E5061A-04A

S E R V I C E N O T E

E5061A ENA-L RF Network Analyzer, 300 kHz to 1.5 GHz

A2 receiver board fails System Dynamic Range specification due to a very few clock signal generation component might not work properly.

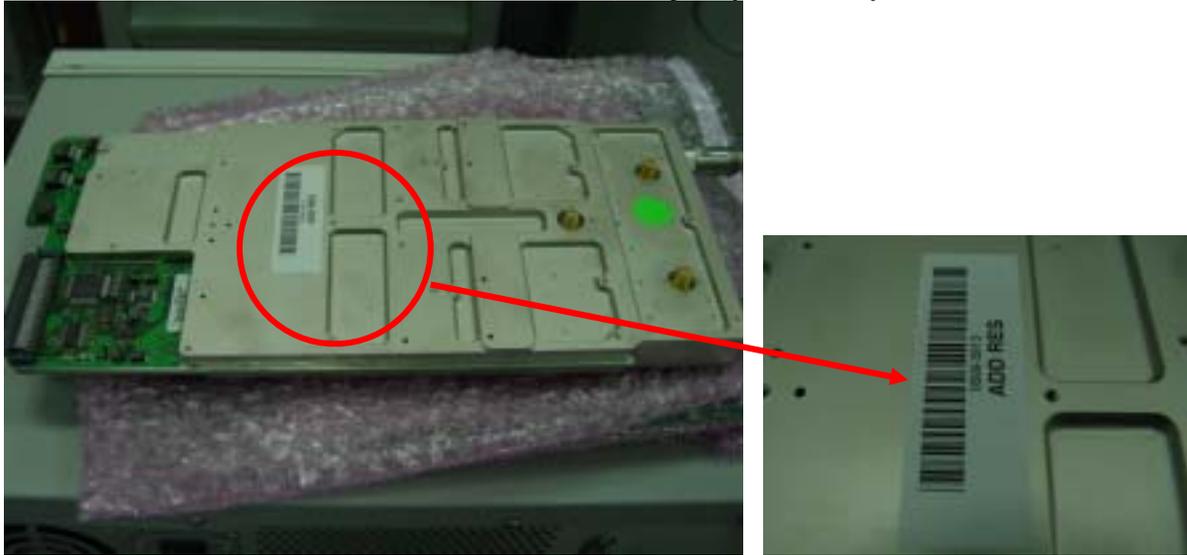
How to identify “good” A2 Receiver Module for this issue

Any of these three cases are “good” A2 receiver module, otherwise return the “bad” module to factory through exchange program.

(1) A2 Receiver Module with “ADD RES” sticker. (Temporary solution by AMC)

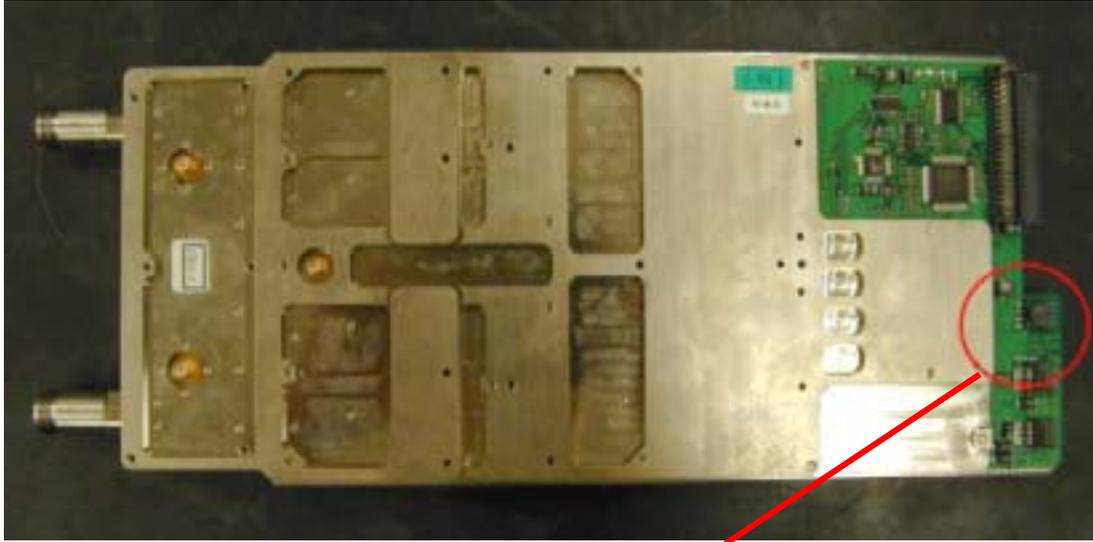
(2) A2 Receiver Module with BARCODE which date code suffix is **-200607**-xxxxxx or later
(Temporary solution by CM)

(3) PCA in A2 Receiver Module is changed from E5062-66502 to **E5062-66512**. (Permanent solution)

E5062-66502 should be changed to E5062-66512
